**Staff Report**
**Zoning & Land  
Regulation  
Committee**
Public Hearing: **May 27, 2025**
Zoning Amendment Requested:
**AT-5 Agriculture Transition District TO SFR-08 Single Family Residential and NR-C Natural Resource Conservation Districts**
Size: **9.89,1.09 Acres**
Survey Required: **No**
Reason for the request:
**CREATING 7 RESIDENTIAL LOTS**
**Petition 12163**
Town, Section:
**MIDDLETON, Section 20**
Applicant:
**ROGER J MEIER REV  
LIVING TR**
Address:
**7616 AND 7628 W.  
MINERAL POINT RD**

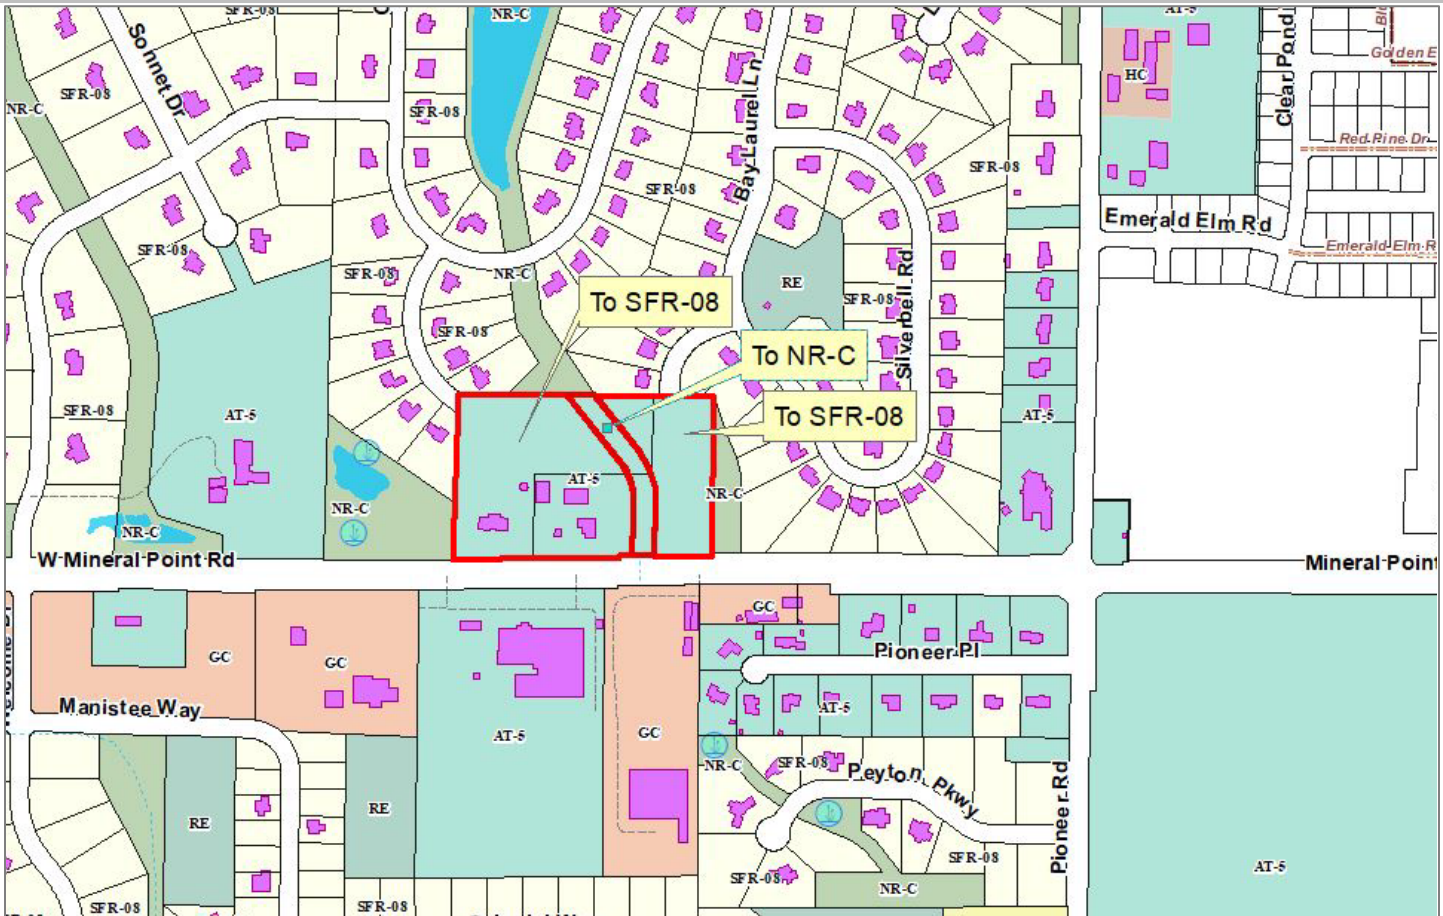
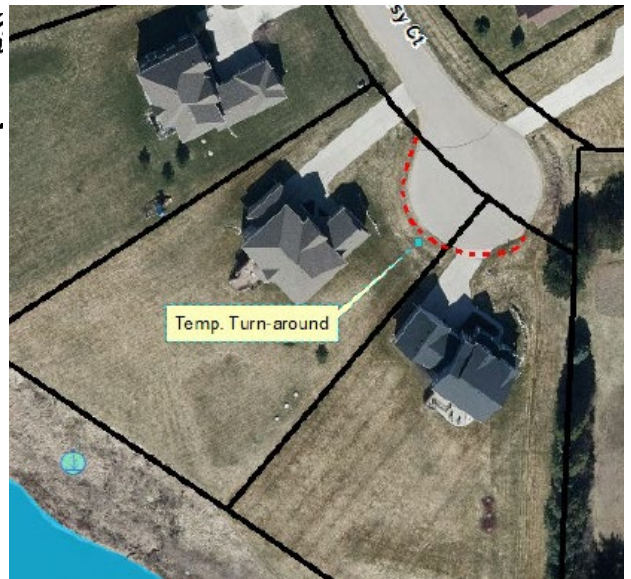
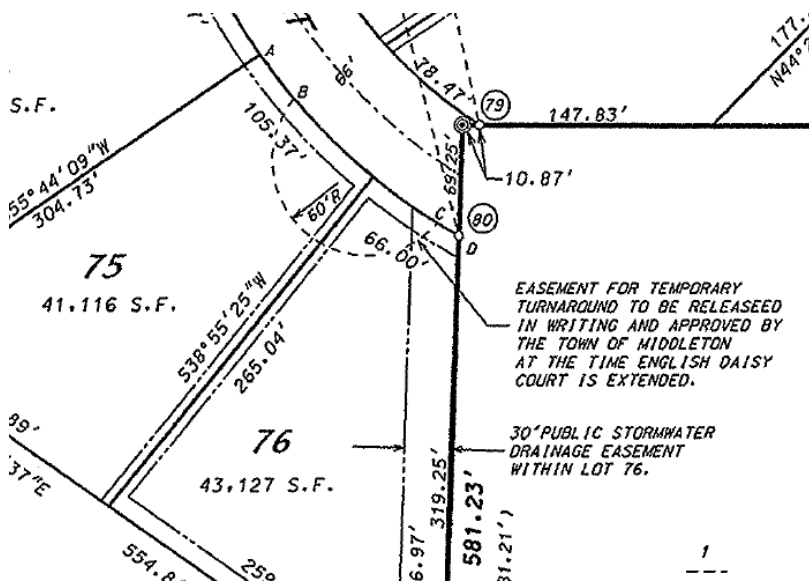
**OBSERVATIONS:** This proposal is identical to the previous one except for one change – English Daisy Court, a town road cul-de-sac, was previously going to be extended into this property to provide the new lots with at least 66 feet of public road frontage (a County land division ordinance requirement). However, due to the cost of extending and rebuilding the bulb, the applicants now propose to leave the bulb in its current location west of the Meier property. This would leave the current bulb in place, which exists as a temporary right-of-way easement over Lots 75 and 76 of the Spruce Hollow plat (see images below).

The plat proposed with this petition would not provide the required 66 feet of frontage for Lots 6 and 7; the lots must be reconfigured to meet county ordinance requirements. See Staff Recommendation section below.

**STAFF RECOMMENDATION:** Staff has discussed options with the applicants to reconfigure Lots 6 and 7 to meet the road frontage requirement. The option of re-platting Lots 75 & 76 of Spruce Hollow and the English Daisy Court right-of-way is not preferred by the applicants. The Town of Middleton has indicated they are willing to leave the temporary cul-de-sac bulb and easement at the end of English Daisy Court. Staff would prefer to see confirmation from the owners of Lots 75 and 76 that they are willing to leave the current configuration in place. The applicants may have an option to make Lot 6 or 7 of this plat into a "flag" configuration in order to provide frontage onto Mineral Point Road, and use a shared driveway easement for access. This would require approval from the Highway Department.

Staff recommends postponement at this time, to allow the applicants time to reconfigure the plat and present an amended proposal to the ZLR Committee.
